RMA Submission Form for Publicly Notified Plan Change 29

SUBMISSION: PLAN CHANGE 29

Figure 1 - Plan of 13 Seymour

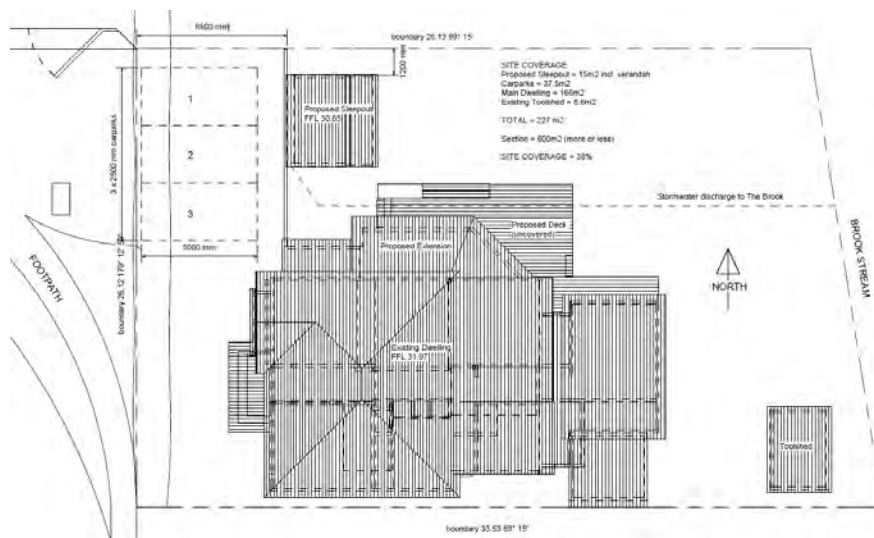
2. Background / context:
 - a. We own and live in the property at the northern edge of the Seymour Avenue Heritage Precinct (#13 Seymour). The property has a northern aspect, with a small yard to the north of the house and small utility area to the rear (east). The northern boundary is approximately 26m long. Refer Figure 1.

Figure 2a: West elevation - Current daylight admission / recession plane (2.5m + 25°)

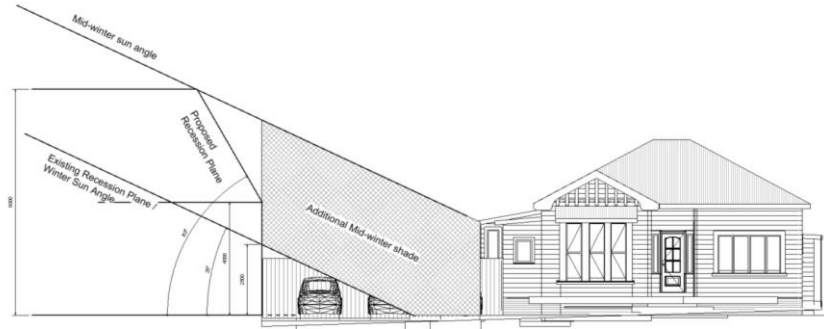
Although the proximity to our heritage property would mean a maximum height of 8m rather than 12m, the impact on our access to sunlight would be extremely detrimental as can be seen by comparing Figure 2a and 2b.

Figure 2a illustrates the midwinter midday sun exposure afforded by existing daylight admissions (2.5m + 25°) and Figure 2b shows the zone of additional midwinter shade that the provisions of PC29 would permit (based on a 25° sun angle). Even with the moderate changes to recession planes proposed for our scenario, the northern side of the living space and the entire yard could lose all access to direct sunlight in winter – when we need it most.

Figure 2c: West elevation (hypothetical) – PC29 recession plane – MRZ, no heritage object (4m + 60°, 12m max)

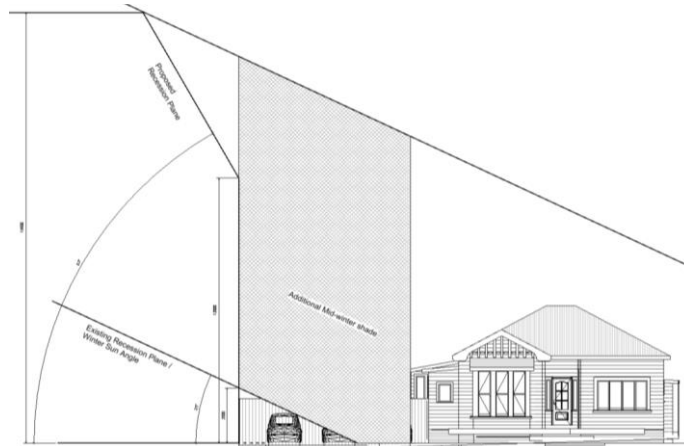
- b. Figures 2c and 2d provide indications of how a property of similar proportions to ours would be affected by PC29 if it was not heritage listed, and was situated in either an MRZ or HRZ. Clearly, by considering daylight alone, there is potential for PC29 to have very significant adverse impact on a large number of Nelson residents and their homes. Council argues that the rate of uptake of potential development may be small (15% over 30 years). However, it is highly likely that every single multi-unit development in the proposed MRZ and HRZ that does go ahead will cause significant adverse impact to one or more established homes, and it is a lottery as to which homes are affected and which aren't. As a result, we feel that residential intensification proposed in PC29 is totally untenable and should be rejected in its entirety.

This statement appears to be either completely false, or intentionally misleading. As illustrated in Figure 2c and 2d, the proposed recession planes in no way protect a property’s right to *direct sunlight* in winter, which is how many residents will interpret this statement.
